**Re: Proposed modifications for additional Viewing Room to Warehouse 1, Bungaribee Industrial Estate, Huntingwood, approval MP10-0140.**

**BCA Assessment Report**  
**Metcash State Distribution Centre**  
**Bungarribee Industrial Estate**  
**Huntingwood NSW**

Revision 4

Figure 1 – Site Plan detailing the extent of the warehouse addition.

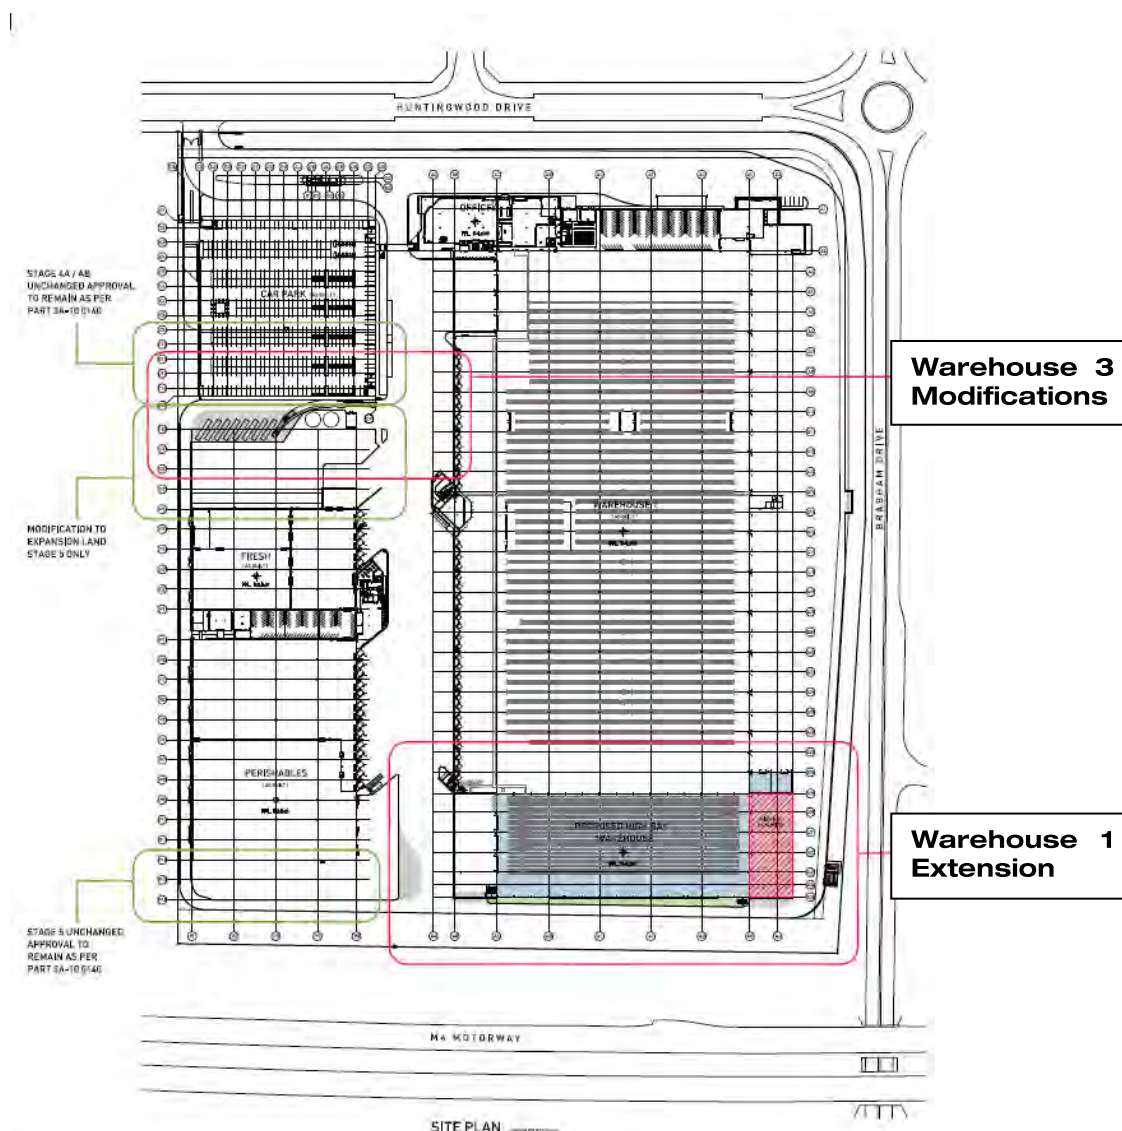
Note 1: The perimeter access road in the South East corner of the new addition appears to be greater than 18 metres from the building. As such, either design changes or modifications to the Base Building Fire Engineered Alternative Solution addressing the Performance Requirement CP9 is required in consultation with Fire & Rescue NSW.

Note 2: The proposed modifications to the north-west corner of Warehouse 3 (stage 5) are compliant with the provisions of C2.4.
